Urgent product safety information

200799955

Karl Storz: Low pressure tube, CO2

2020-02-26

Figure 1: Correct inner diameter
5.9 +0.12 mm

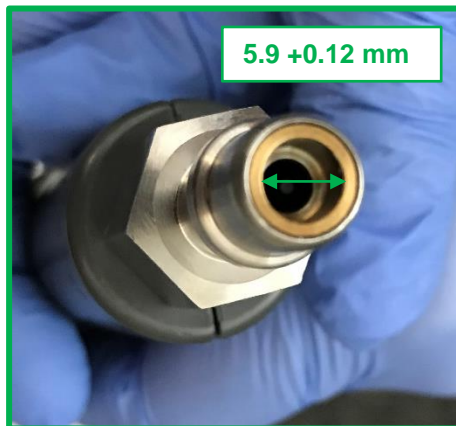
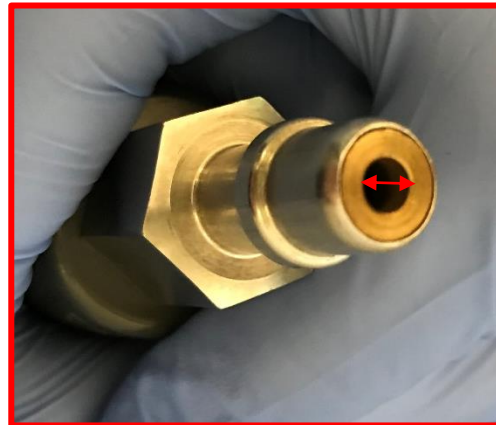
Karl Storz has been informed that the low pressure CO₂ tubes stated above may contain an incorrect component in the connecting plug. The diameter of the component deviates from the specified dimension.

Inadvertently connecting the CO₂ plug to an O₂ connection point may result in a flow of gas under certain circumstances. The CO₂ plug will not engage fully in the O₂ connection point; however, it is possible that, if a misaligned connection is established and tension is therefore exerted on the tube, the plug may become wedged in the connection point, resulting in a flow of gas. If connected correctly, the plug would have to be pushed all the way into the O₂ connection point in order to establish a constant gas flow.

1. Check your stocks immediately. Locate all potentially affected products and check their inner diameter (see Figure 1). The article number is located on the respective product. Faulty products must be returned to Karl Storz SE & Co. KG. Contact your sales representative/distributor to arrange for a replacement.
2. Forward this product safety information to any internal parties who may be affected.
